SUBJECT: Site Plan Review for 6288 Hudson Crossing Parkway
Parcel #30-09749

PC Case No: 2018-3892

Date: June 4, 2018
To: Kris McMaster City Planner, Community Development
From: Thomas J. Sheridan, P.E., P.S., Asst. City Manager
Re: **Hudson Crossing Site Plan Review – Site #42**

SUBJECT: 6288 Hudson Crossing Pkwy - Premier Development Hudson 42 Building

DEVELOPMENT PLAN

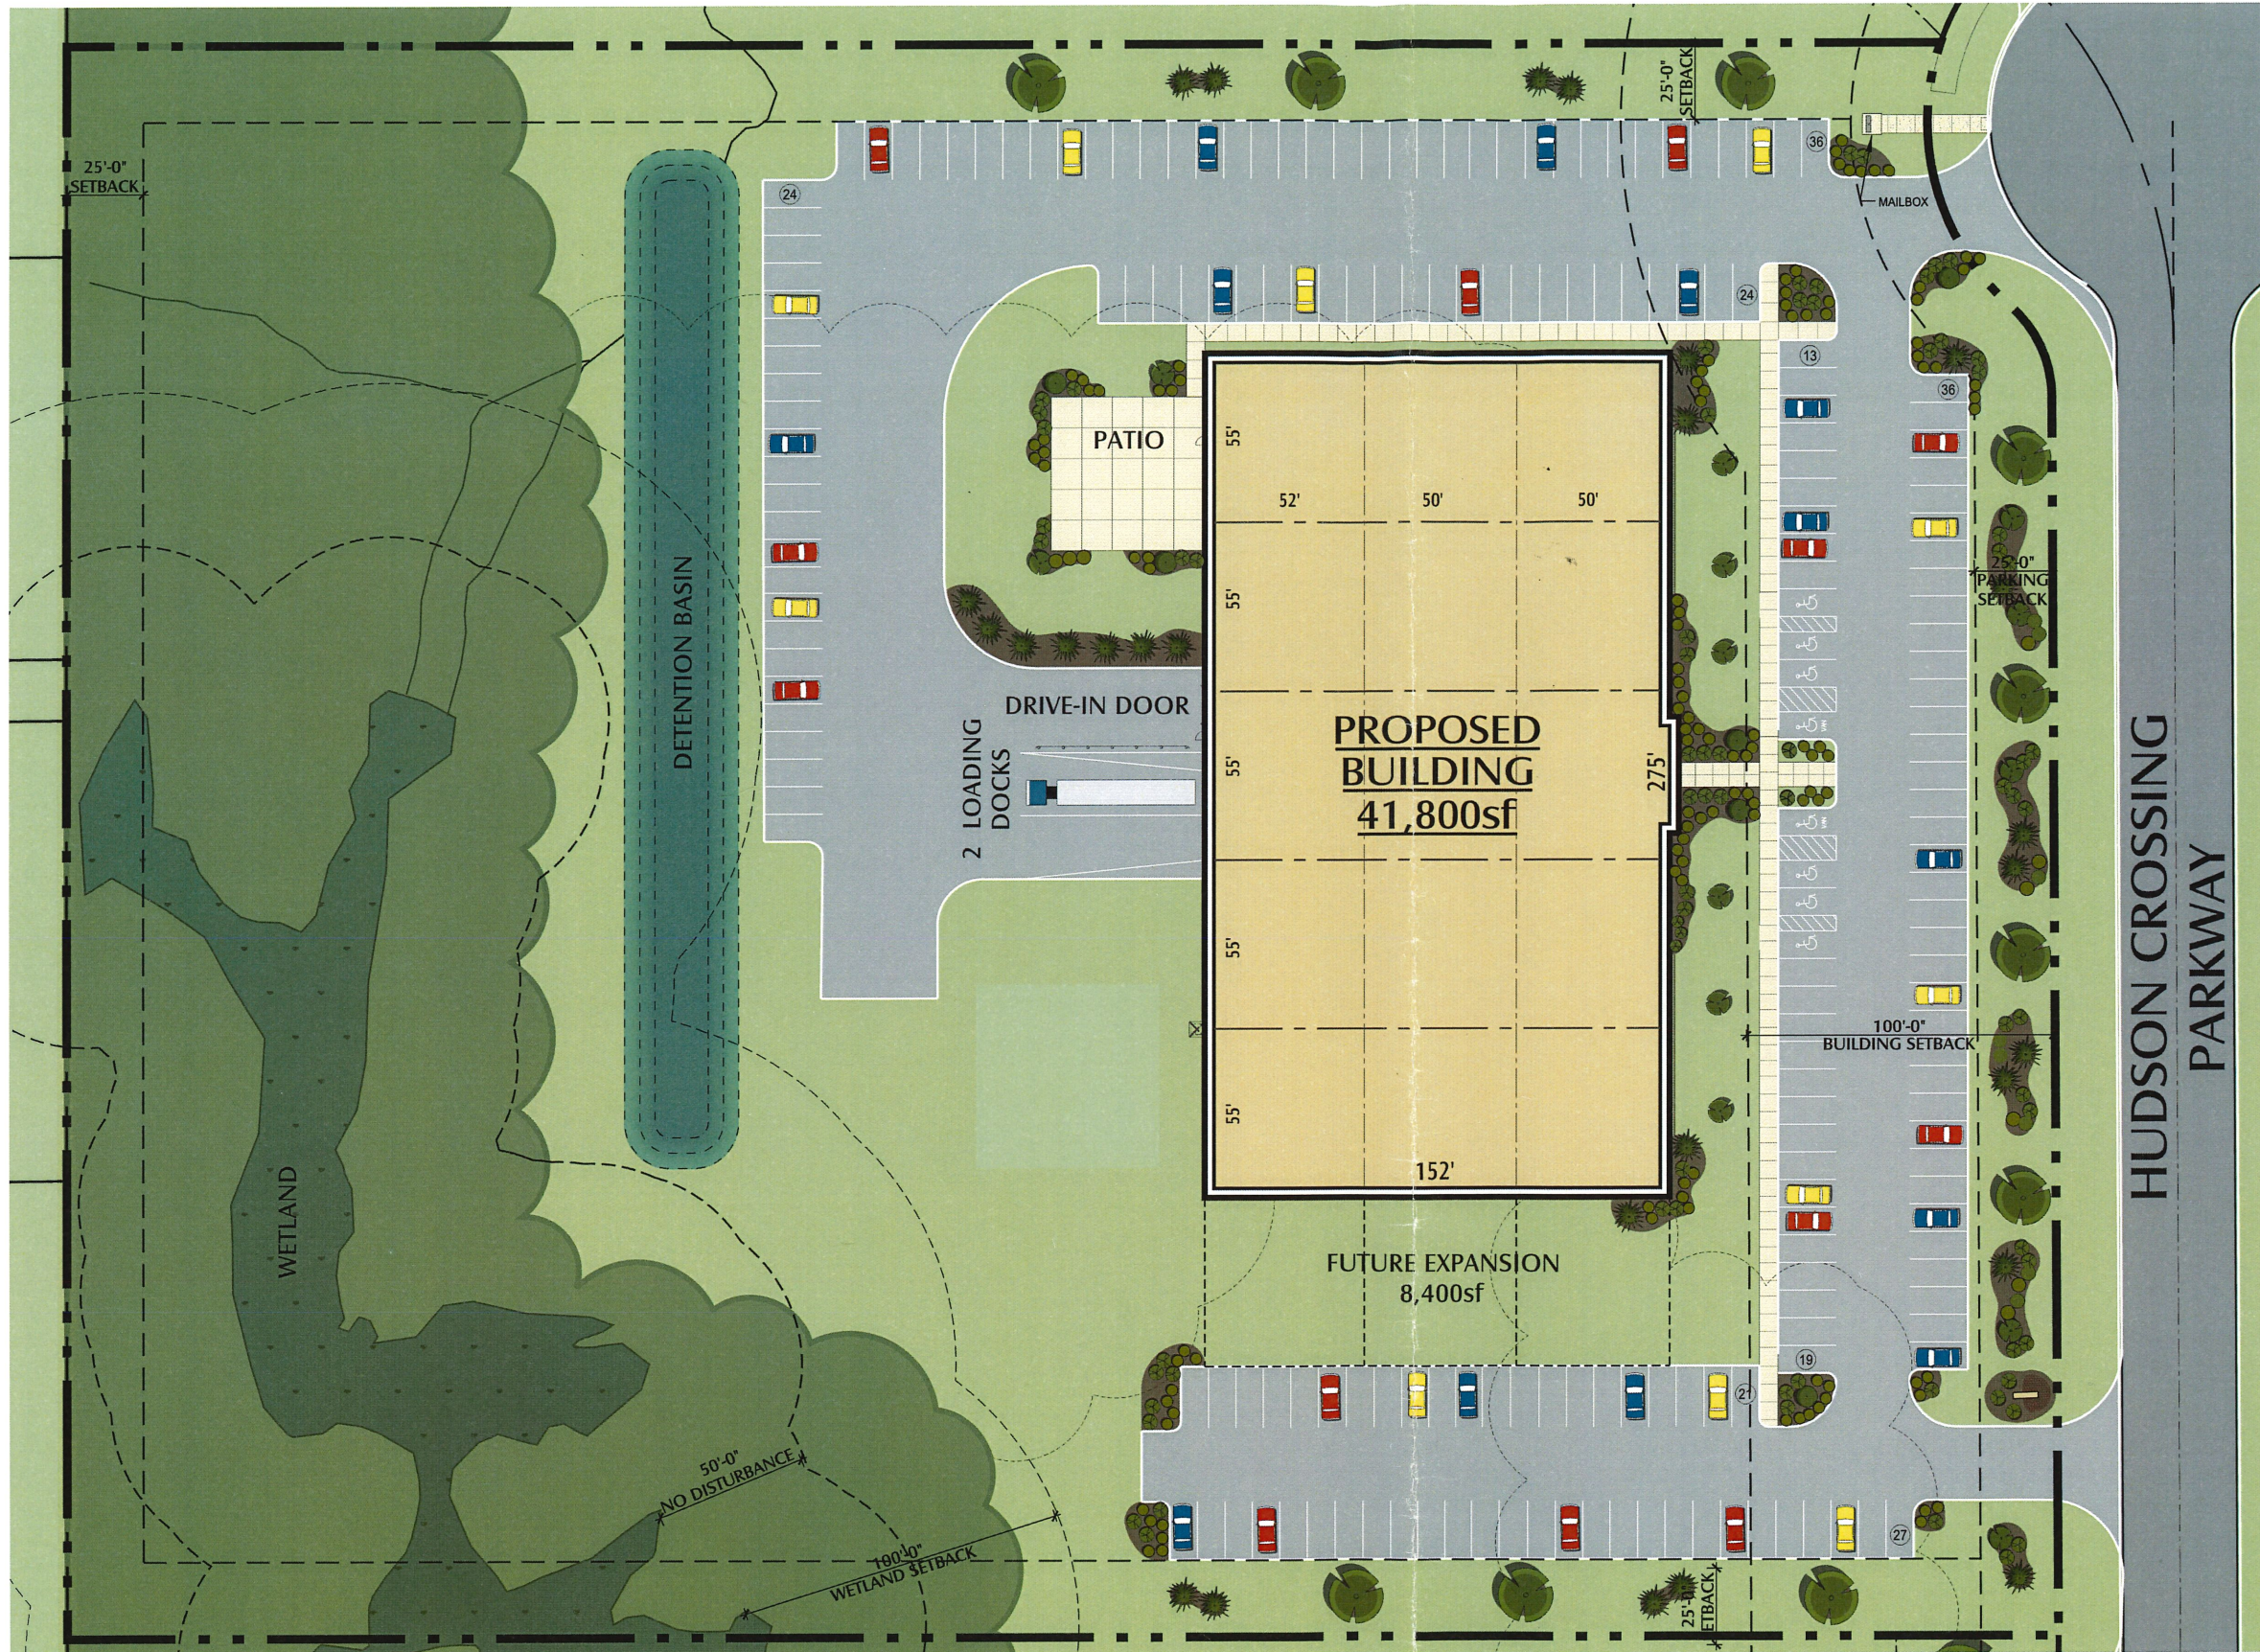
The applicant has appropriately proposed a sidewalk along the parking lot connecting to the building entrance along the front and side of the building and to the rear patio area. A sidewalk will be required along the future expansion on the southside of the building and should be noted on the plans as it will affect the parking layout. The developer of the business park has also indicated a multi-purpose path will be installed to provide the continuous pathway along the full length of Hudson Crossing Parkway. Add sidewalk access to the pathway.

Vegetation Protection: Silt fencing and limits of disturbance needs to be depicted on the site plan.

- The City will perform a full review of the final plans when they are submitted.
- Note: A sidewalk will be required along the future expansion on the southside of the building. Please note as it will affect the parking layout.

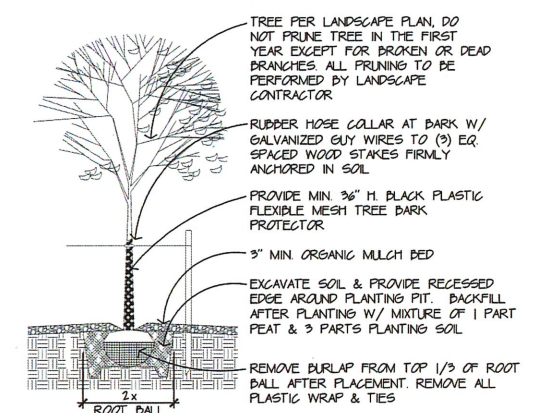
Landscaping: The concept site plan indicates appropriate areas to accommodate the necessary front yard, street trees, perimeter parking lot, and interior island landscaping. A final landscaping plan will need to be submitted and accepted prior to authorization to proceed.

5. An exterior lighting plan including photometrics must be submitted in compliance with applicable standards of Section 1207.18(g).
6. Landscape plan shall be submitted prior to issuance of the zoning certificate.
